T10/06-470 revision 5

Date: January 23, 2007

Subject: SAS-2: Transport layer read data flowchart

Figure 1 — Representation of transport layer (i.e., ST_TTS1 and ST_TTS3) read data operation

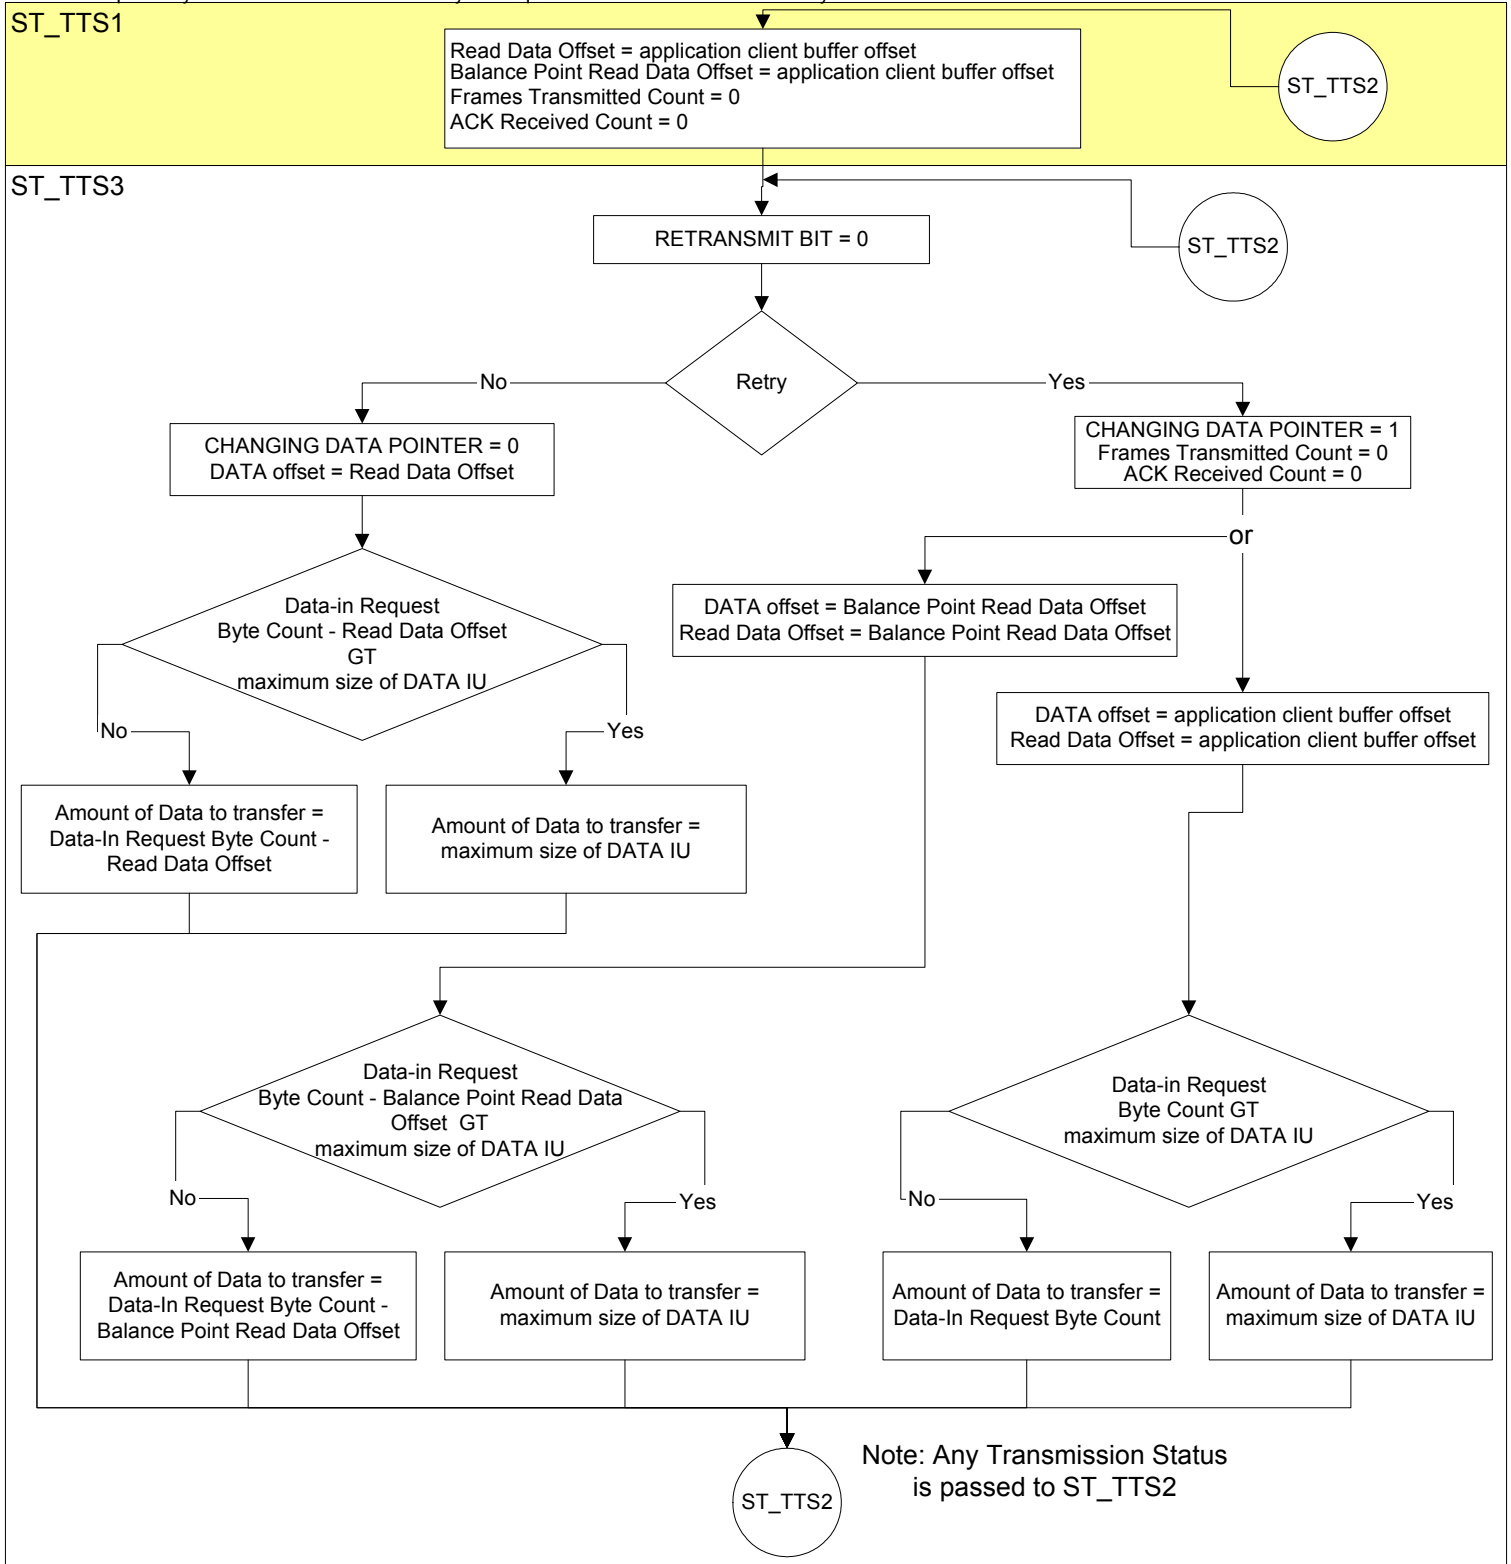
In the process of converting the words that are currently in SAS-2 there were no errors found, however, some of the wording may be somewhat unclear. Also, it was discovered that one of the conditions described in ST_TTS3 can never happen and another is already checked in ST_TTS2 so this proposal is recommending that they be deleted. See below the flowcharts for the suggested changes.
